POST OCCUPANCY EVALUATION

AMESBURY SCHOOL CHURTON PARK, WELLINGTON

Date: April 2015
Reference: 1-46083.00
Status: Final v15

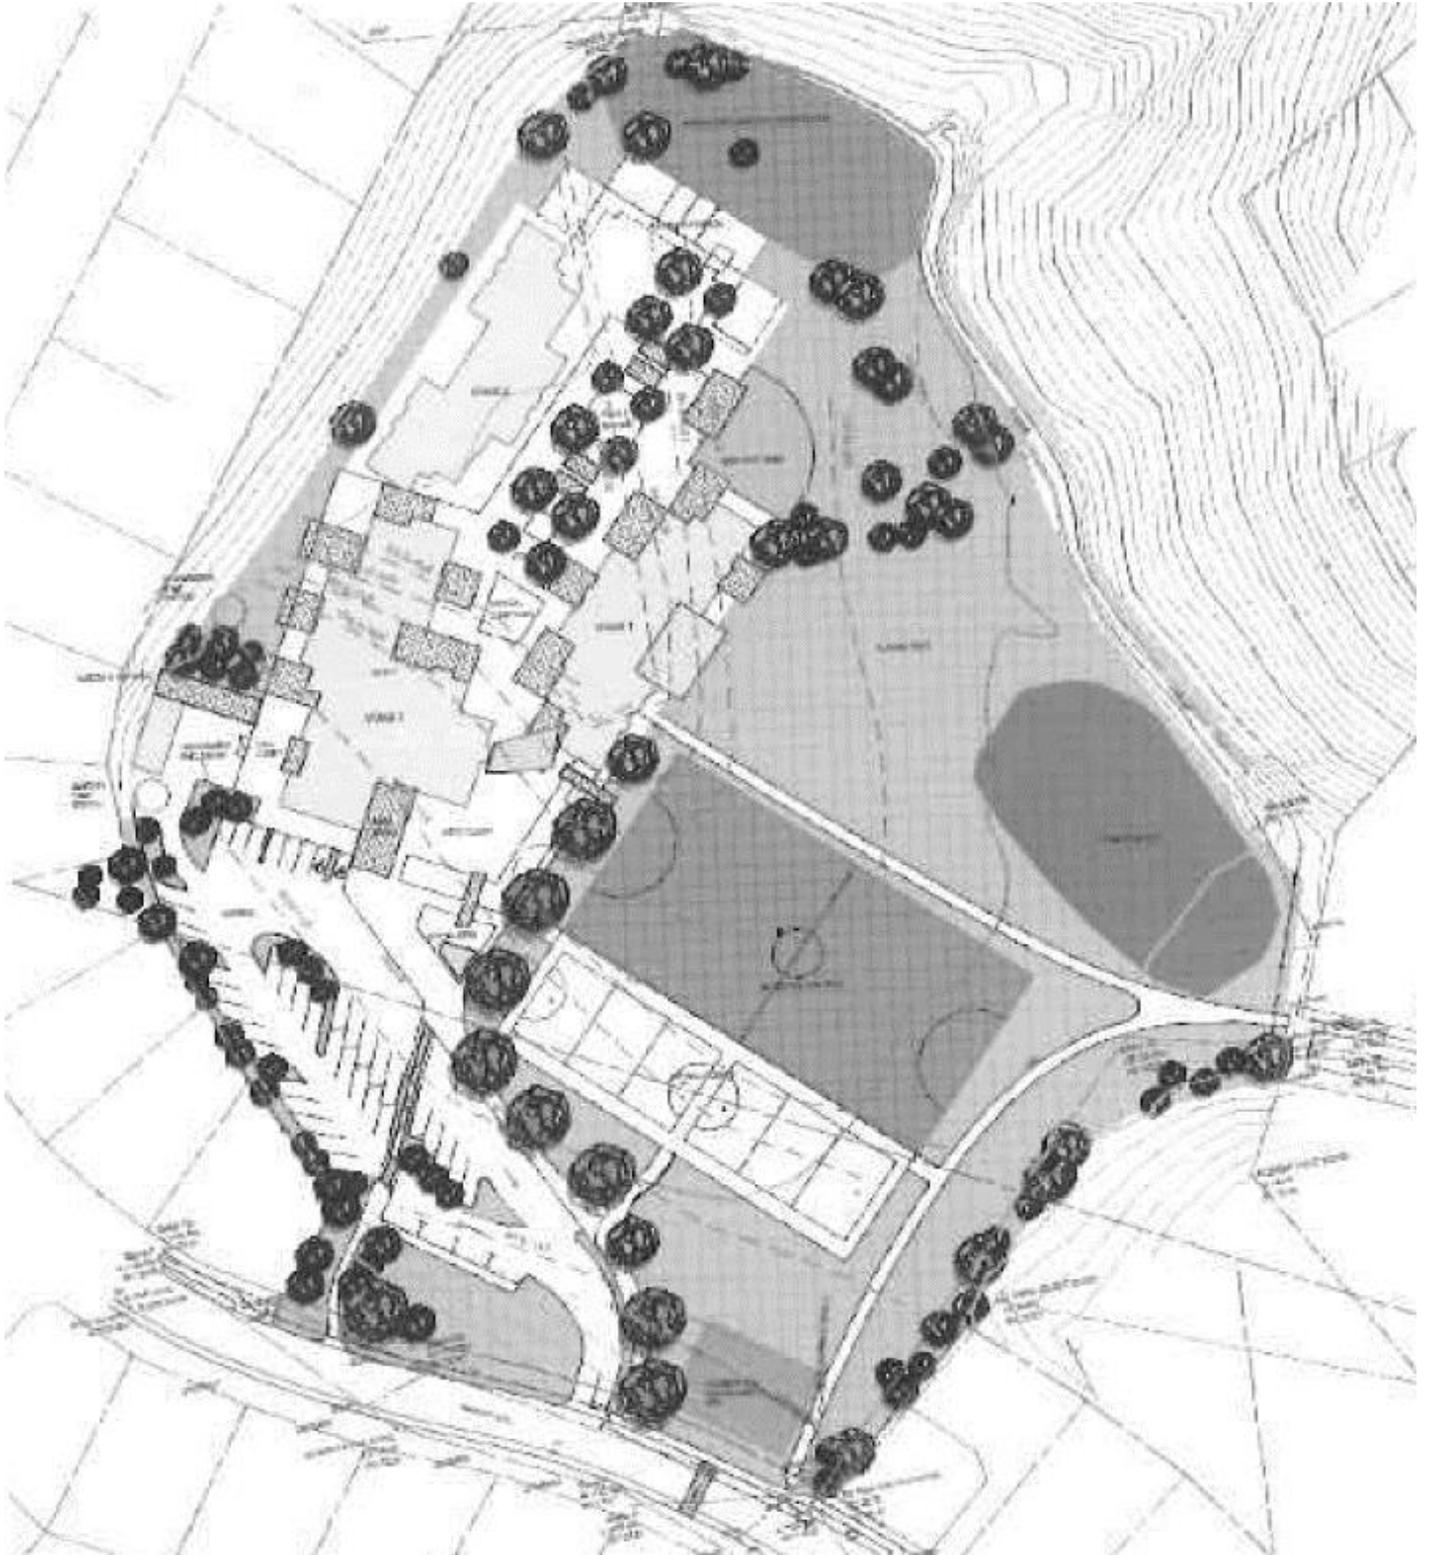
From the perspective of the post evaluation process, however, there were clear shortcomings in the design and its execution, some being minor and some more significant. This points to partial failure in the design and procurement processes.
